Dunmore Quarry – Modification 9

Response to Submissions

Dunmore Quarry | Modification 9
Croome West Pit

Report J16050RP4 | Prepared for Boral Resources (NSW) Pty Ltd | 17 August 2017

Figure 22 –Middle Dam Daily Seepage Loss Rates

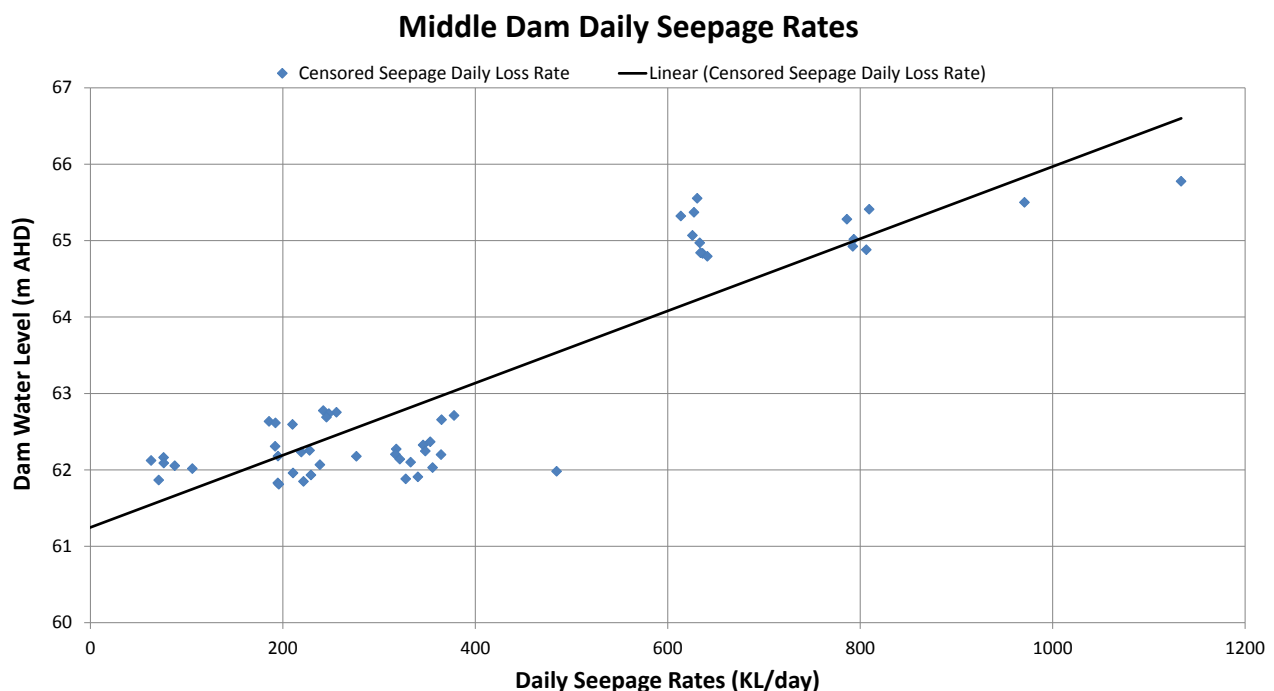
5. *The surface water assessment provides dam management options but selection of a preferred strategy has been deferred while monitoring is completed. The proposal options vary significantly in the volume of controlled discharges (381 ML/yr? In option 1, ~240 ML/yr? In option 2). Figure 21 and Figure 22 depicting proposed water balances under dry and median years are the same and Figure 22 contradicts Figure 24.*

- *Review and replace Figure 21/22 with correct figures and confirm predicted volume of controlled discharges under each option.*
- *Provide a timeline for selecting the preferred strategy.*
- *Describe the how the risks and impacts from the different options vary and how these would be managed/mitigated.*

Seepage losses from the Middle Dam were applied to the water balance using a linear water level / seepage rate relationship indicated by the trend line in **Figure 22**.
